# NGC Base HV Breakdown Study

D. Mack

9/20/21

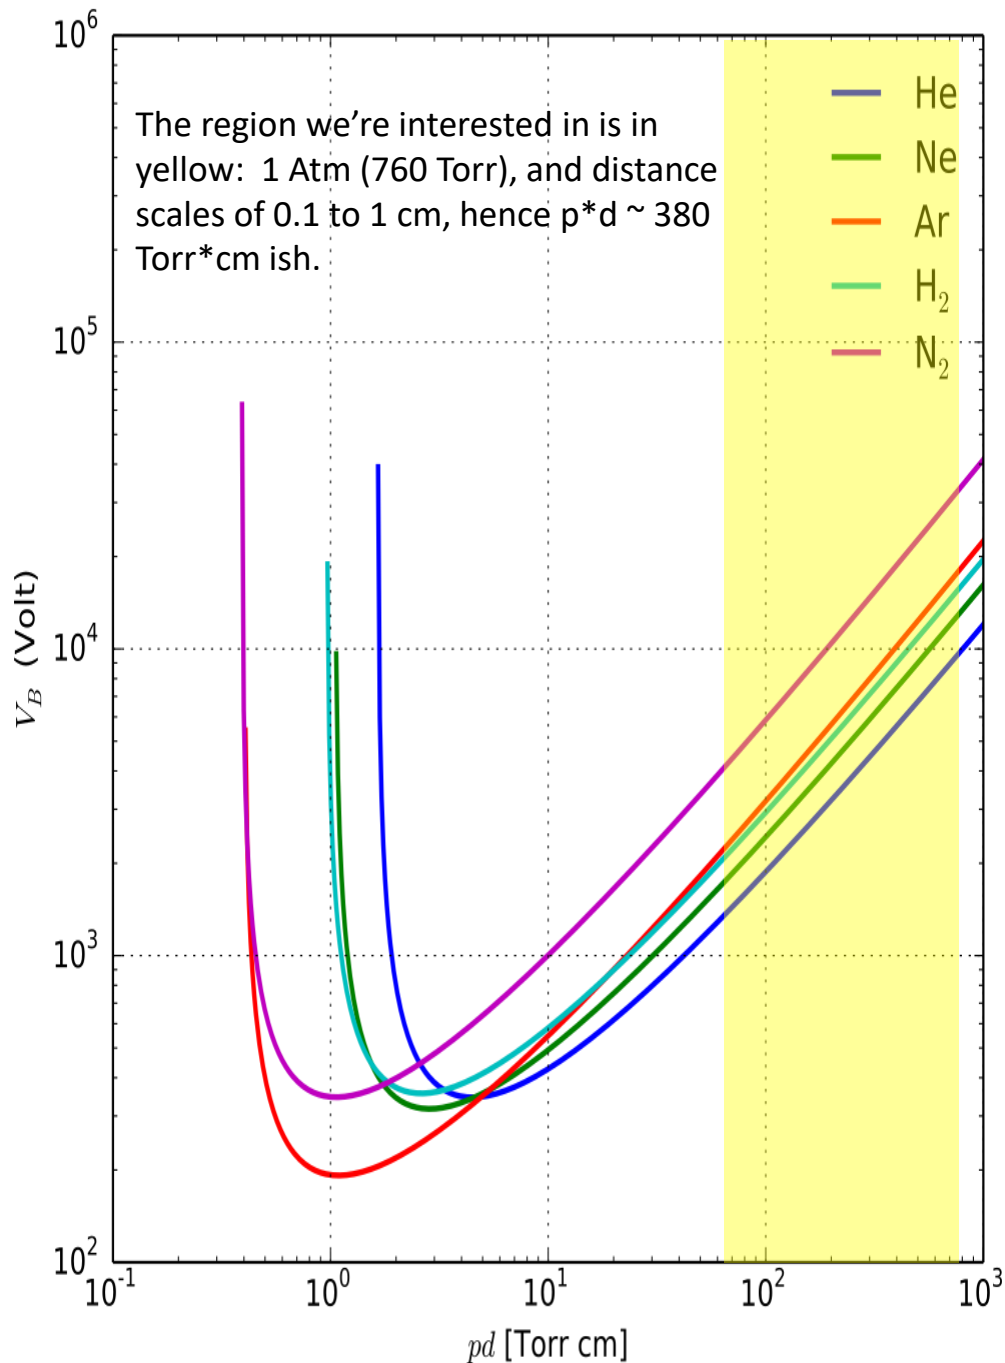
Here's the voltage divider diagram. Low potential areas in blue, and high potential in red.

Normal NGC signals are negative. In hlog <https://logbooks.ilab.org/entry/3901680>, Simona saw a large negative signal followed by a much larger positive signal. Given that we're occasionally blowing FADC channels, perhaps +HV is sparking inside the base to the ground and/or signal lines.

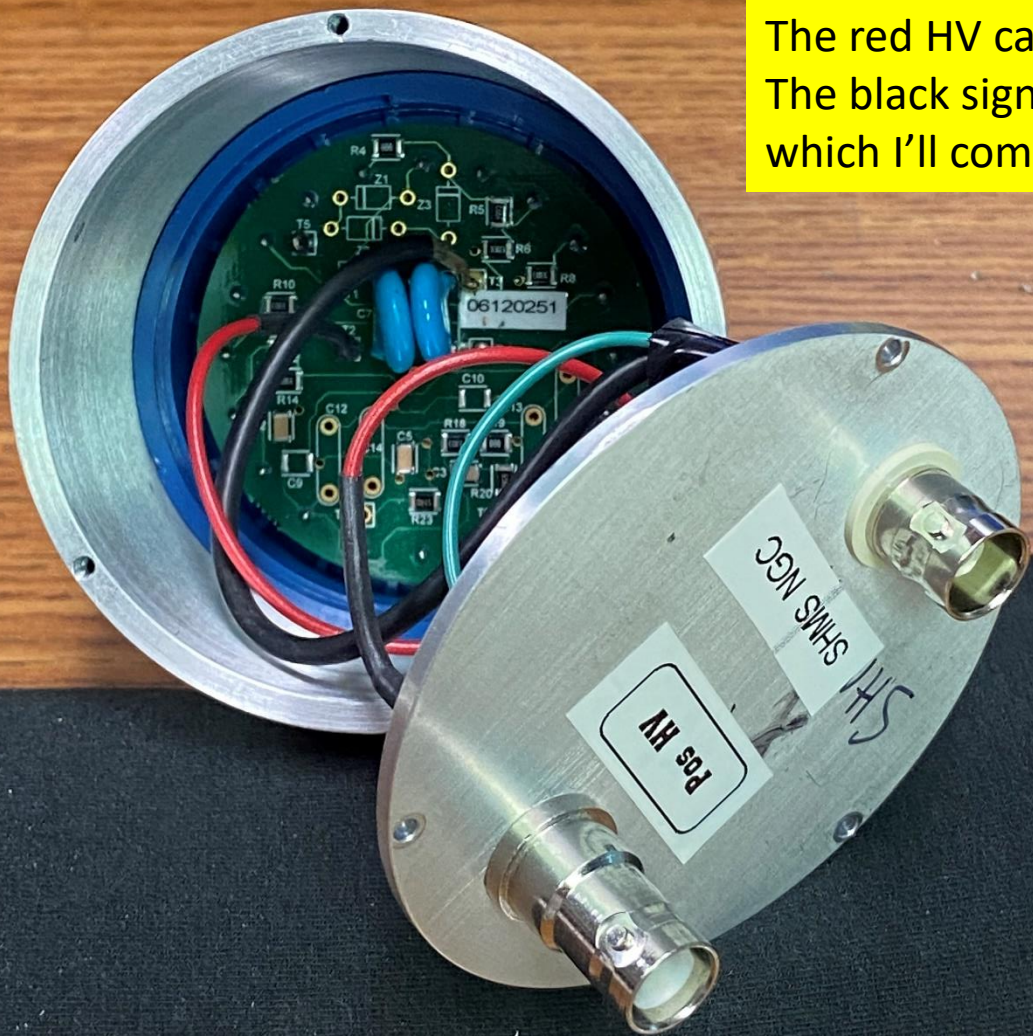
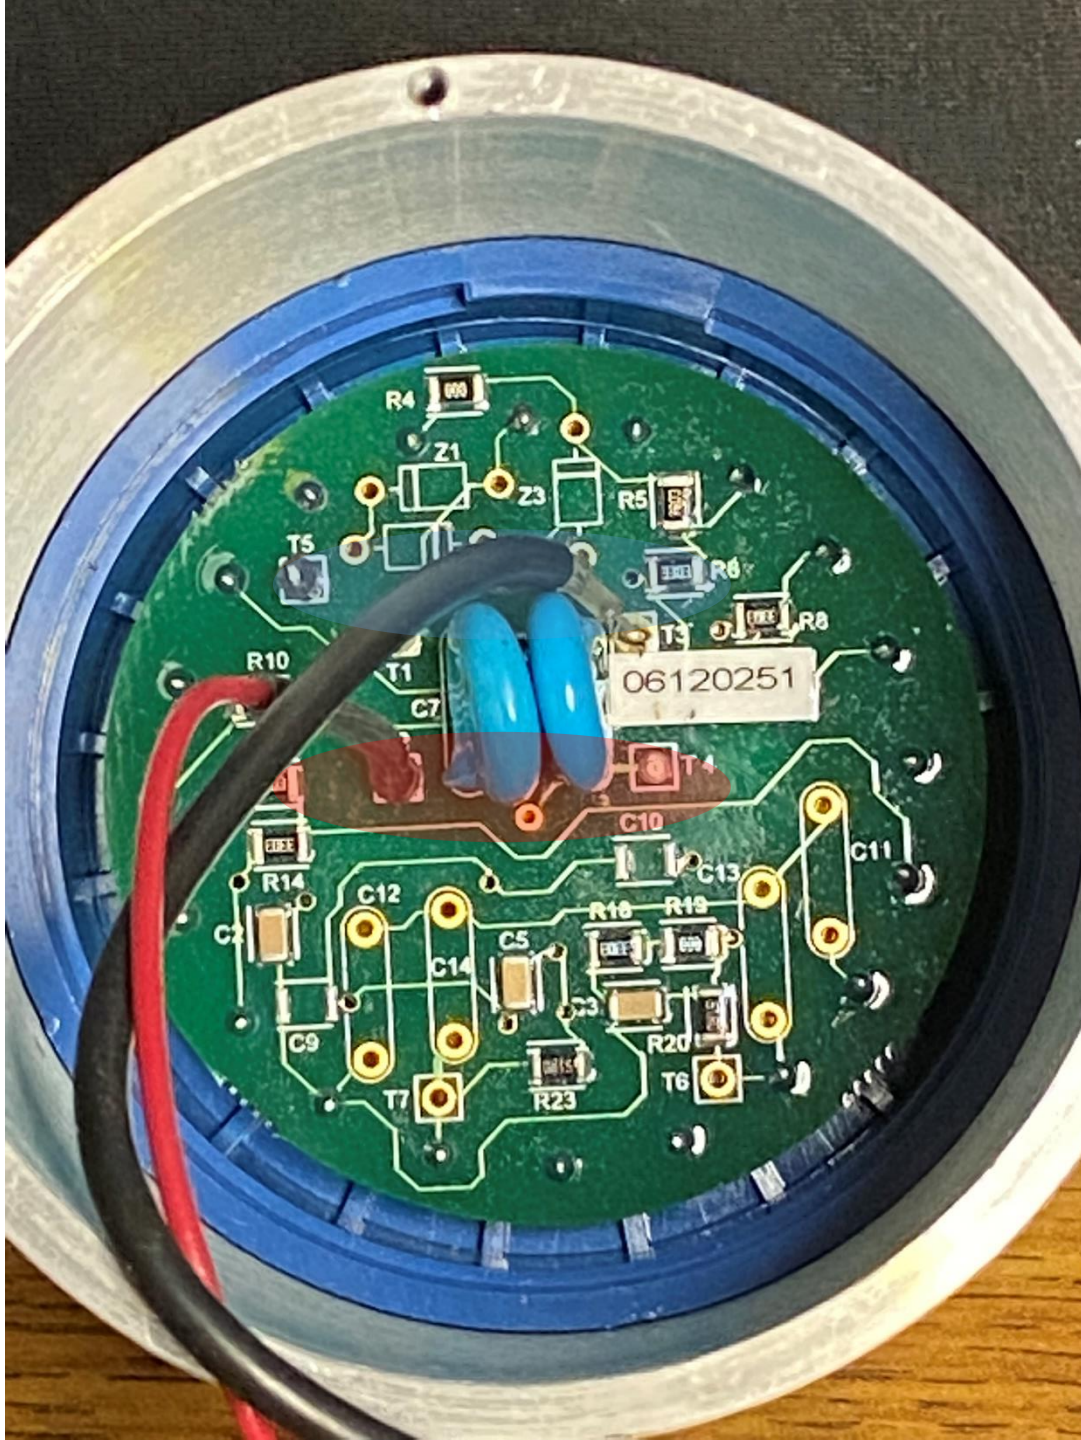
I've marked low potential areas with **blue**, and high potential with **red**. Potential increases systematically with resistor number.

Those two large blue caps each have one leg near ground, and one leg near full +HV. **Definitely a region of interest.** (corresponds to a min distance of 8mm for d2 and d3 in the Argon tech note)

Some solder bumps on the periphery are near max potential. And sharp enough to hurt when lightly pressed with a finger. **Another region of interest since a grounded casing will be installed.**

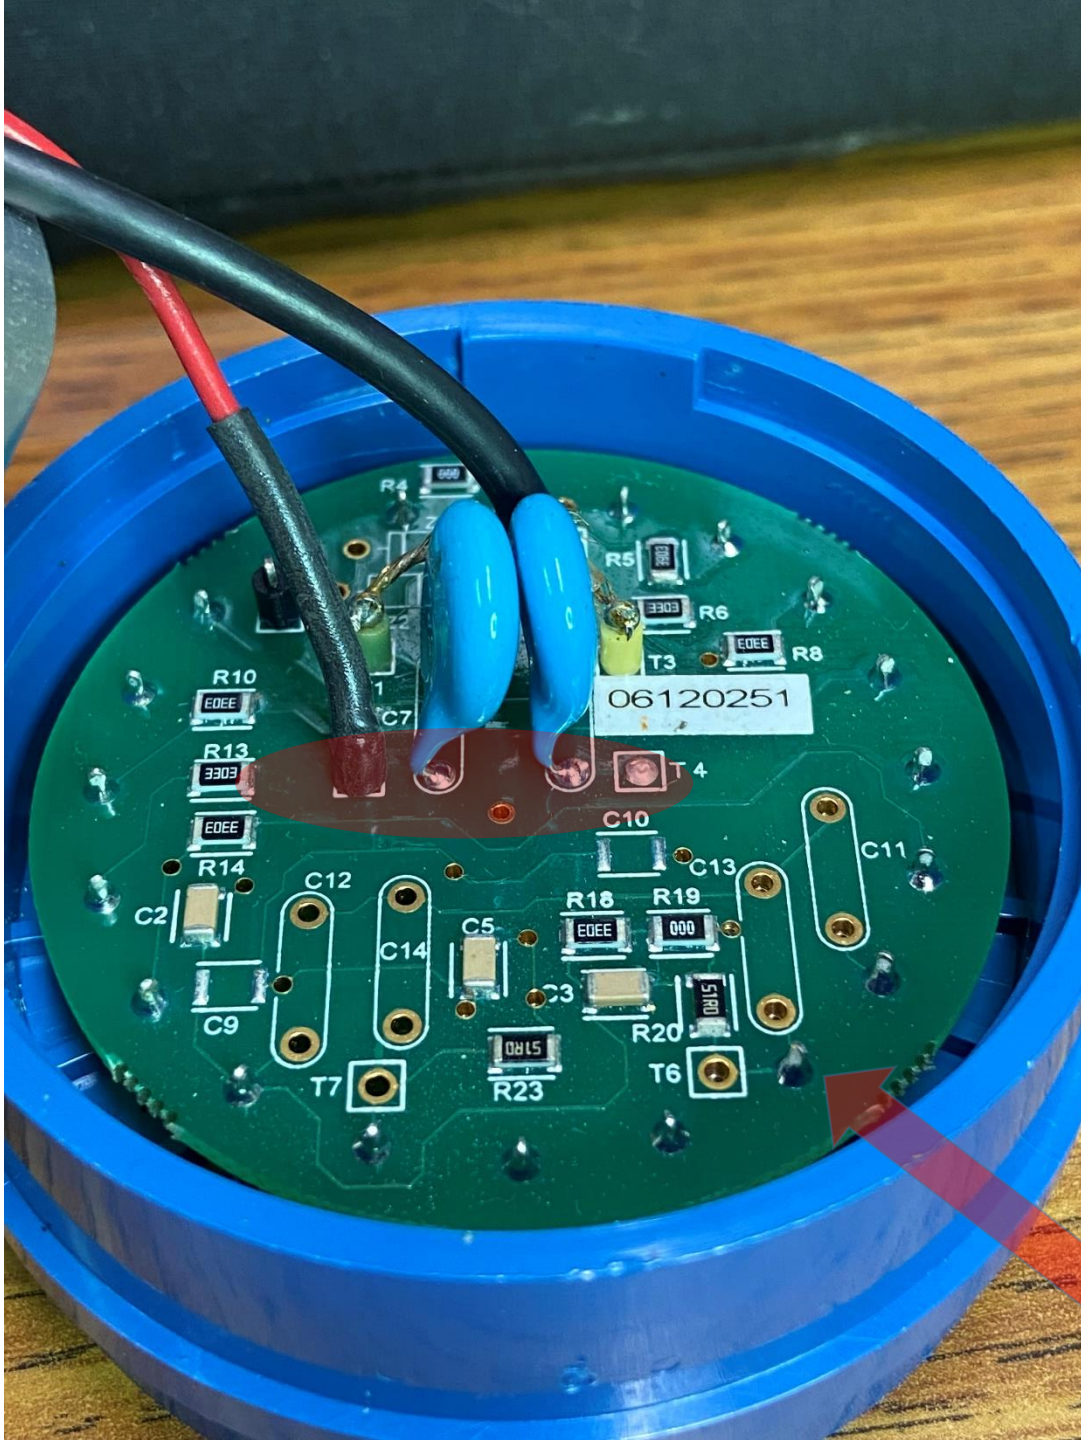
Because the board is recessed in its big blue socket, the near-spikes on the periphery are ~8mm from the grounded metal casing. And they were coated after the board was stuffed.\* So I'm not too worried about these near-spikes.

\*The fine print on the circuit diagram says "The board is conformally coated with Anti-corona lacquer RS 569-313." Other wording indicates that the big blue caps were added by hand, so the blue cap legs might **not** be coated.

The HV cable (red) is gorgeously terminated. No worries there.

The two near-side legs of the big blue capacitors, which are in clear view, are at full +HV.

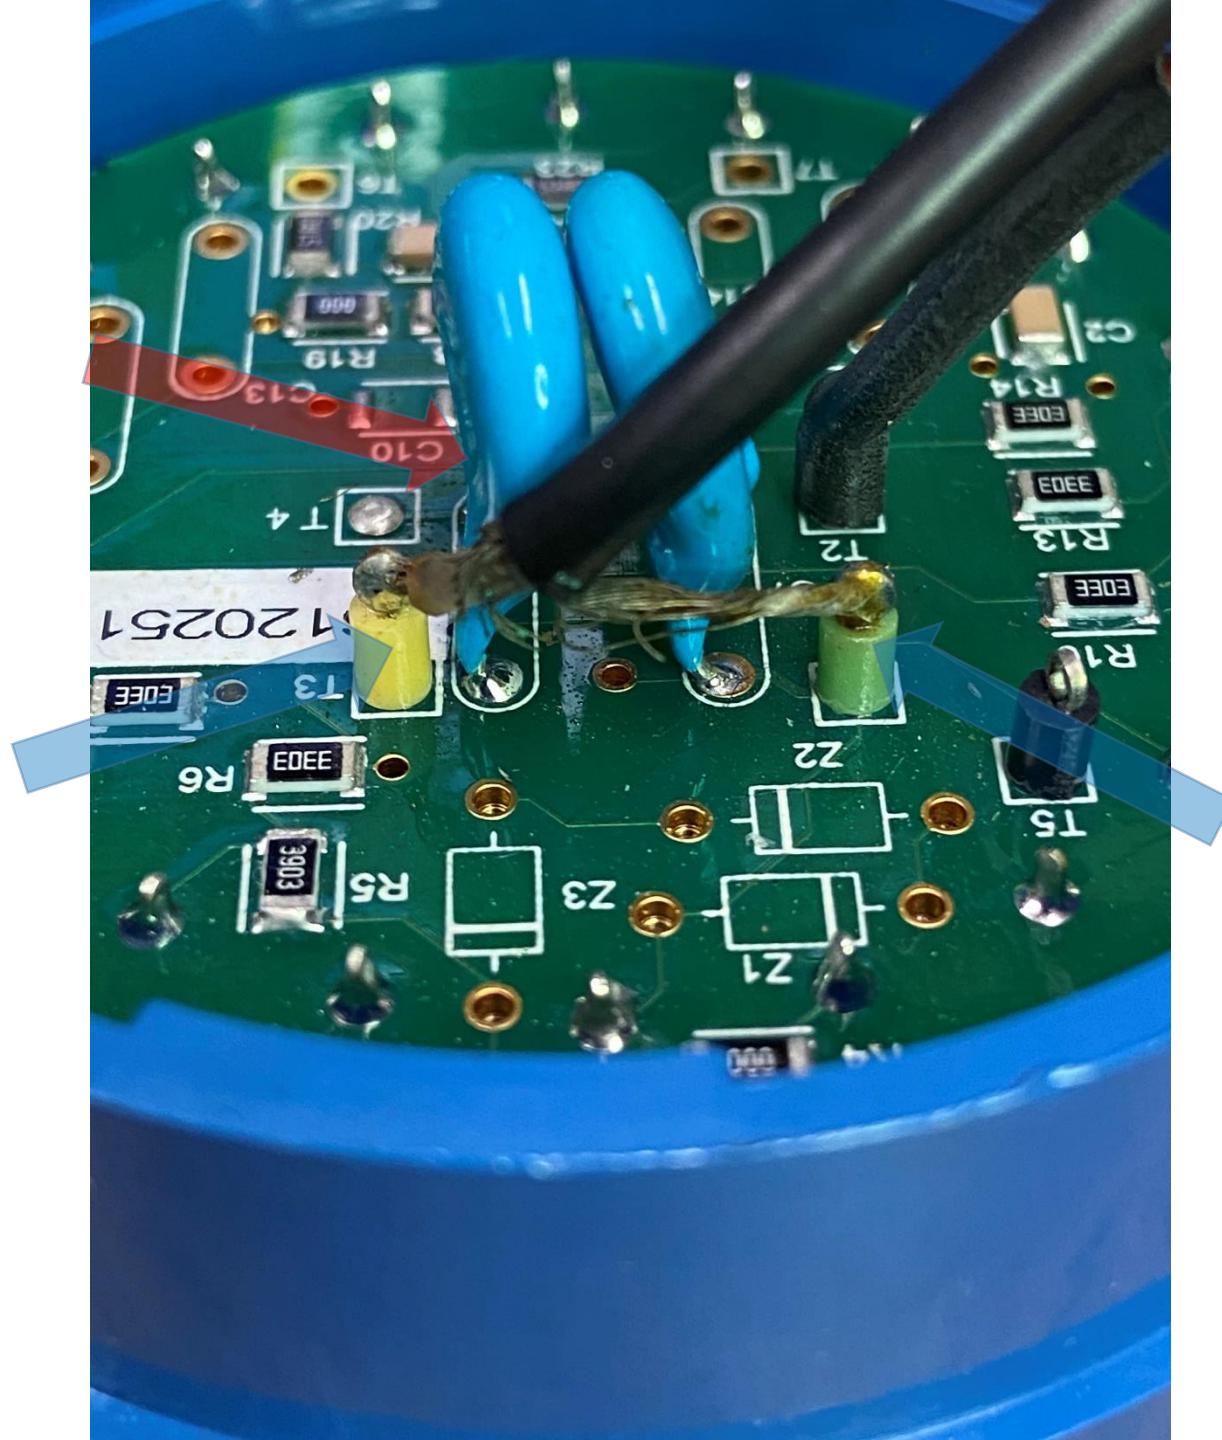
(Btw, from this oblique photo, you can better see the ~2mm height of the near-spikes on the periphery. Since higher resistor numbers mean higher potential, the biggest risk for near-spike sparking would be in the lower right corner.)

Ground is on the far-side legs of the big blue capacitors. Looks a little odd. Let's flip this around on the next slide.

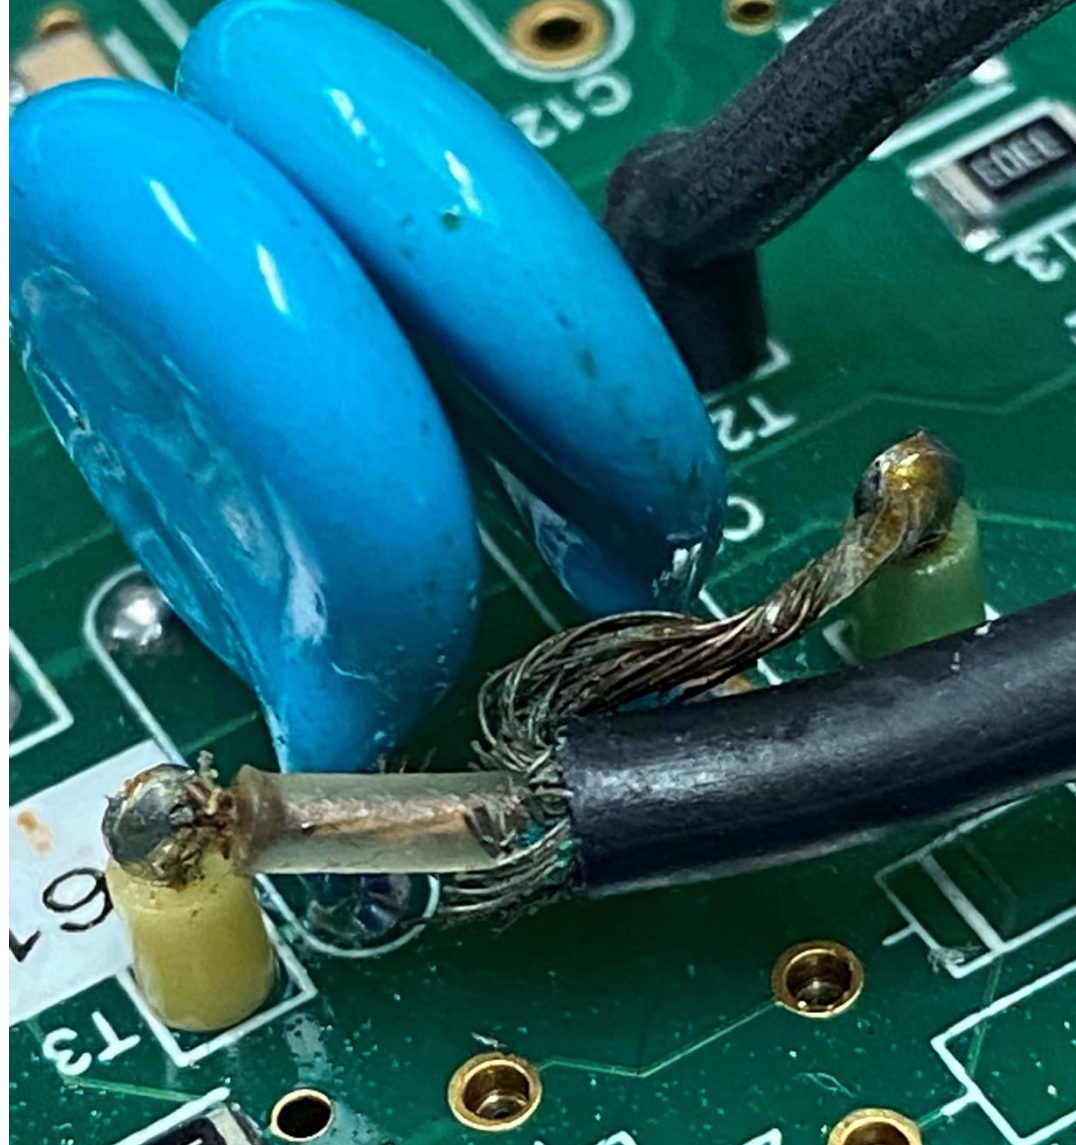
Ouch. The ground braid has a lot of wild hairs.

Not only are there sharp wire ends, but in this example some of them may reduce the gap size from 8mm to 6mm.

In a brief test at 2300V in air, I could not make this base spark. That's expected, since an air gap would have to drop to only ~2mm to start sparking infrequently.

But these stray ground braid wires are the kind of variable that could cause some bases to have less than 4mm gap and maybe start sparking in a Neon-rich atmosphere.
